AGENDA
VILLAGE BOARD MEETING
Tuesday, December 8, 2020 at 7:30 p.m.
Jackson Village Hall
N168 W20733 Main Street
Jackson, WI 53037

SECTION 00 63 63 CHANGE ORDER

Change Order No. 4

**VILLAGE OF JACKSON
MUNICIPAL COMPLEX**

DRAWING SHEET REF: ES100

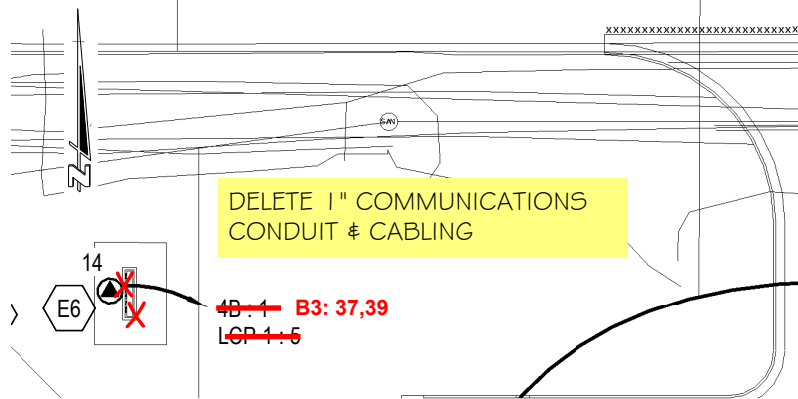
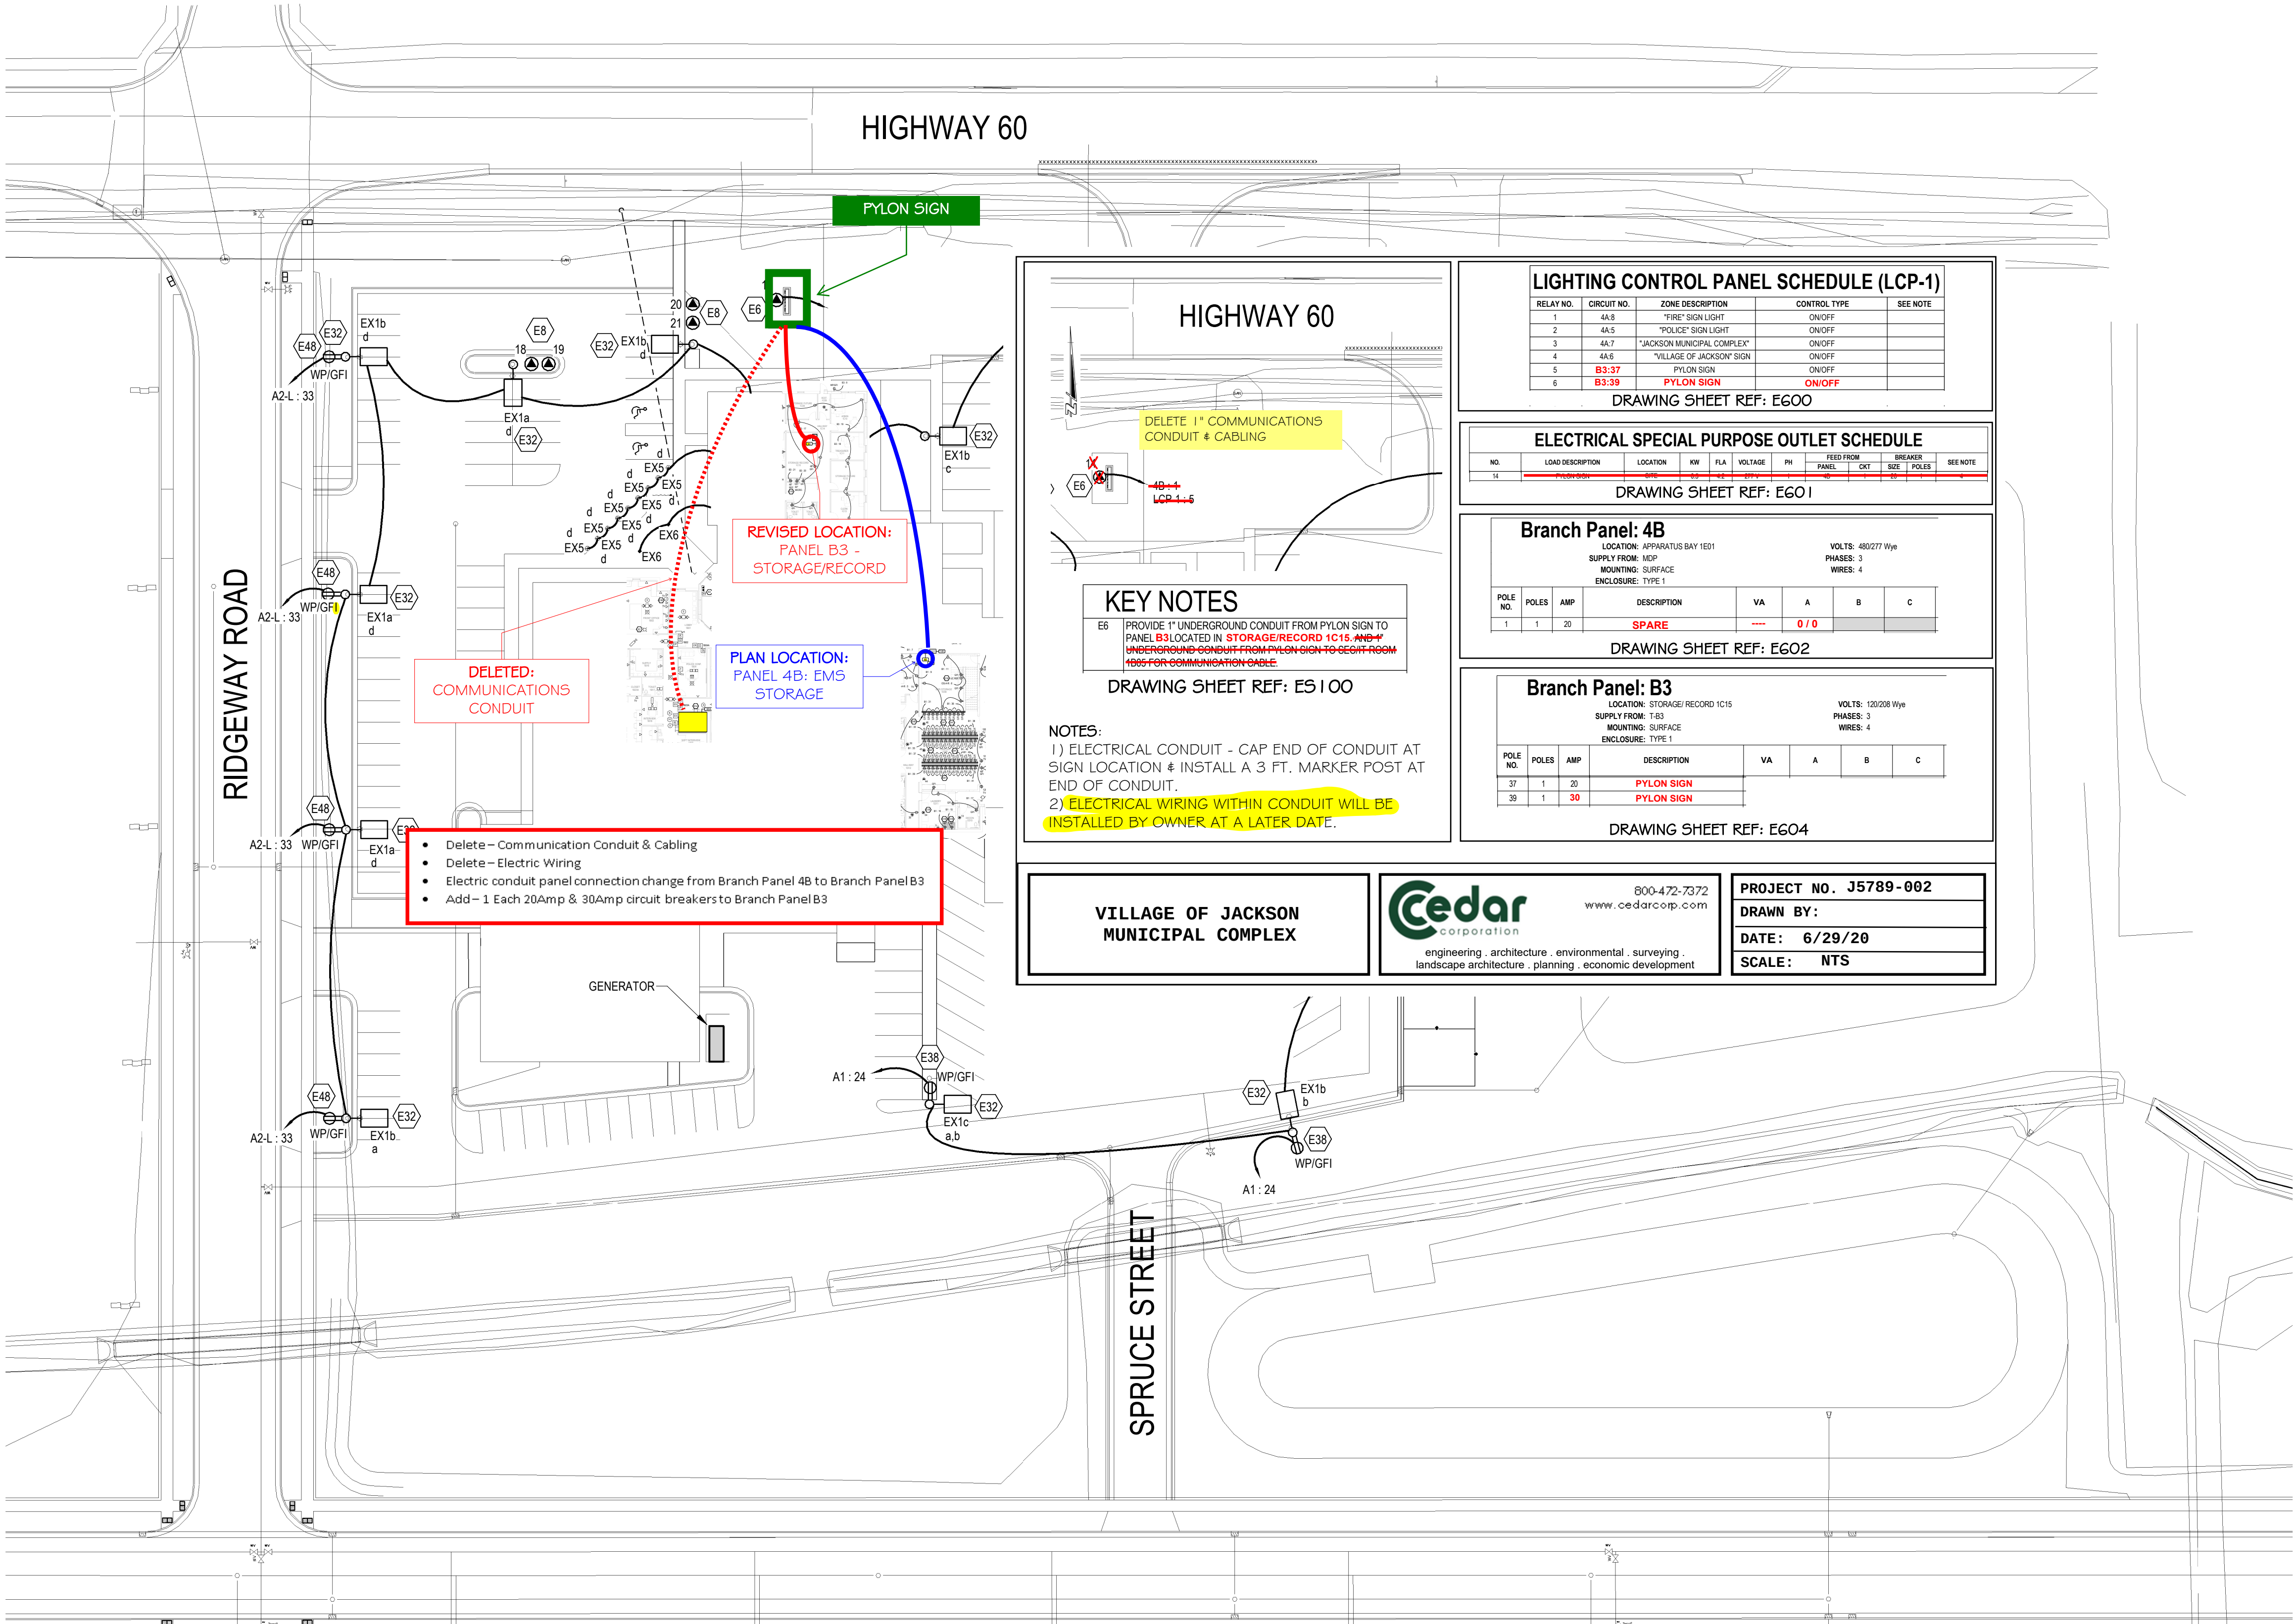
- a) Change Order Item No.1: Revisions to proposed communication and electric conduit number, lengths and locations based upon Owner's evaluation of needs and/or preferences for the proposed monument sign.

This conduit was already rough in to the building foundation. We just needed to extend it to its original location Per Drawing with the power conduit.

We interpreted sheet note E6 on the ES100 drawing dated 3/02/20 as conduit rough in only. Sheet Note E6 reads "Provide 1" Underground Conduit from Pylon Sign to Panel 4B Located In EMS Storage 1D08 and 1" Underground Conduit from Pylon Sign to SEC/IT Room 1B05 For Communication Cable".

Sheet Note E46 on the same drawing specifically calls for "Run Direct Burial Gel Filled Cat 6 Cable for Camera in A 1" Conduit to inside Apparatus Bay..." hence our reasoning for not including any cabling for the Sign location.

- E6 PROVIDE 1" UNDERGROUND CONDUIT FROM PYLON SIGN TO PANEL B3 LOCATED IN **STORAGE/RECORD 1C15**. ~~AND 4" UNDERGROUND CONDUIT FROM PYLON SIGN TO SECURIT ROOM 4B05 FOR COMMUNICATION CABLE.~~
- PROVIDE (2) 30 AMP RELAY INTERCONNECTED TO THE NETWORK LIGHTING CONTROL SYSTEM LOCATED ADJACENT TO PANEL BOARD B3 TO CONTROL CIRCUITS AS AN ON/OFF FUNCTION PER LIGHTING BASIS OF DESIGN. FOR THE 20 AMP CIRCUIT RUN #10 WIRES AND FOR THE 30 AMP CIRCUIT RUN #8 WIRES BOTH IN A 1" CONDUIT**

**Village of Jackson
Municipal Complex
Elevator Shaft Revision**

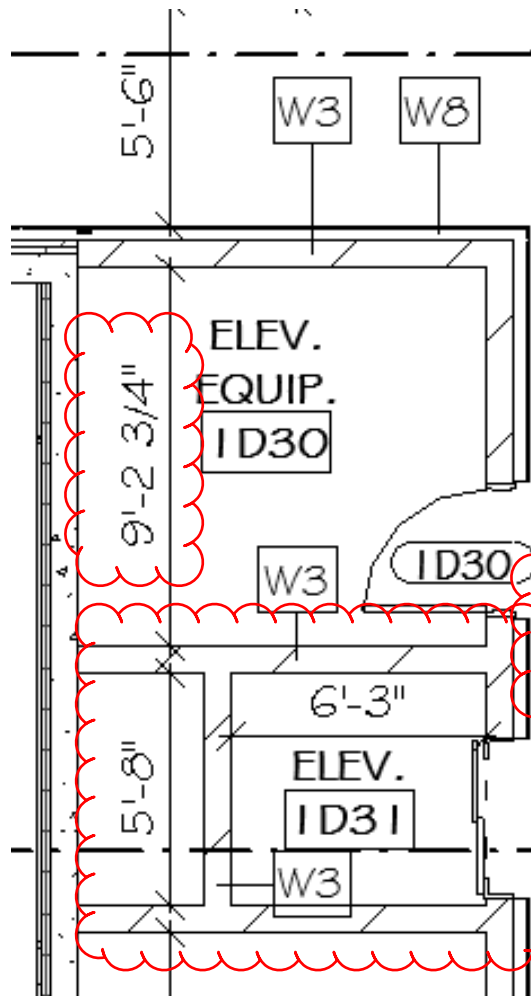
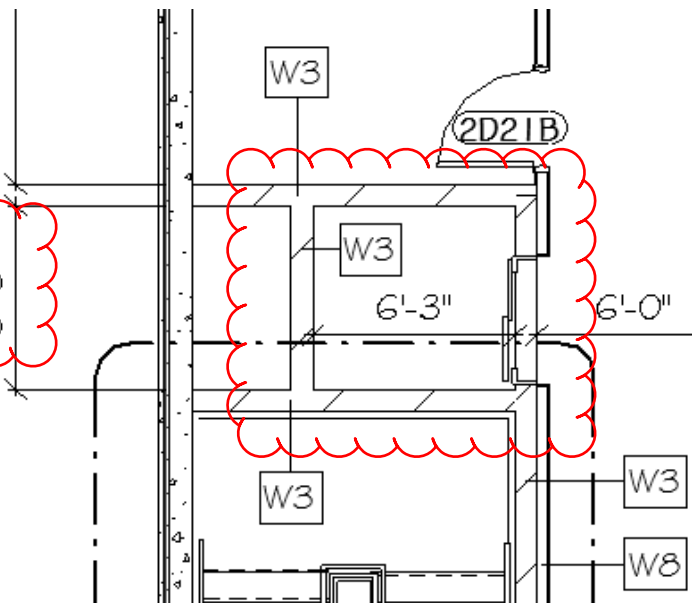
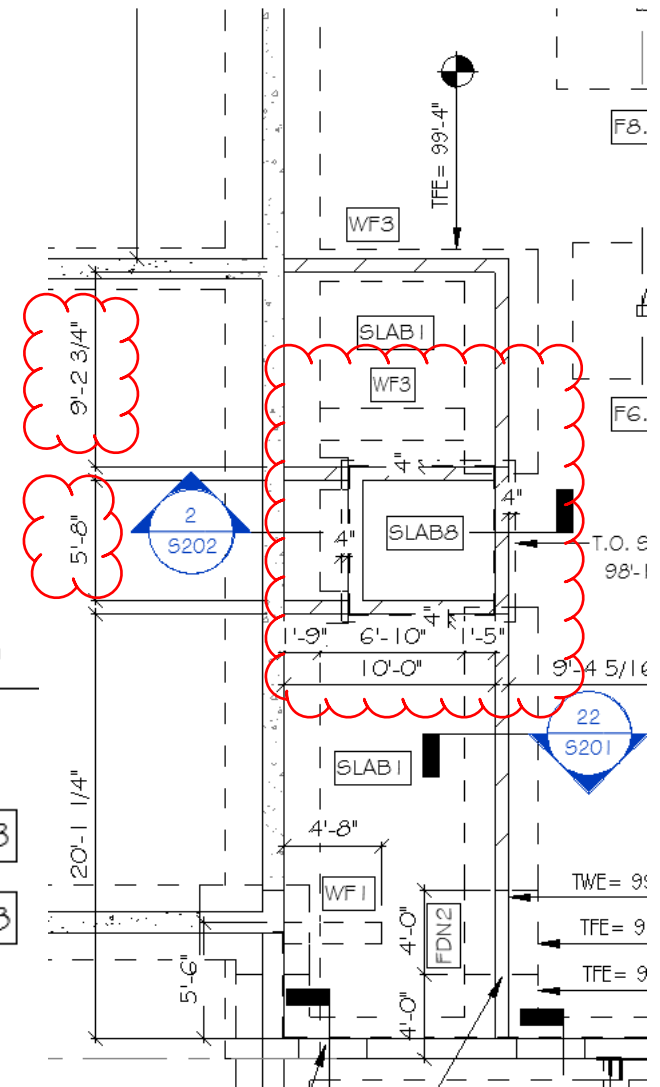
- b) Change Order Item No. 2: Based upon Contractor's elevator shop drawing submittal, required size of equipment required a revision of shaft size resulting in relocation of proposed shaft walls/wall foundations.

Mike Koenig Construction Co. Inc. proposes to supply labor, materials and equipment to complete the elevator shaft revisions per the drawing revision provided on 9-1-20 and per the following specifications.

- Saw cut and remove foundations already installed
- Add CMU wall on west side of shaft per drawing
- Extend second floor metal deck and concrete topping

- Remove current foundations at east and south wall of elevator shaft
- Revise base slab dimensions
- Add CMU wall at west side for reduced elevator shaft size.
- Add second floor metal deck and concrete and steel angle at north wall of elevator shaft for deck bearing

PCO #15: Added Rip Rap

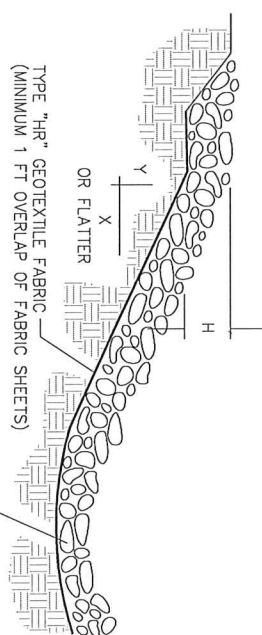
- c) Change Order Item No. 3: Re-evaluation of the building's roof drain pipe discharging within the storm water pond embankment, the volume of water could create soil erosion. Therefore, rip rap material was installed from the point of pipe discharge to the pond's normal water elevation.

Mike Koenig Construction Co. Inc. proposes to supply labor, materials and equipment to complete provide and install rip rap at the roof drain outfall per drawing dated 10-6-20 and per the following specifications.
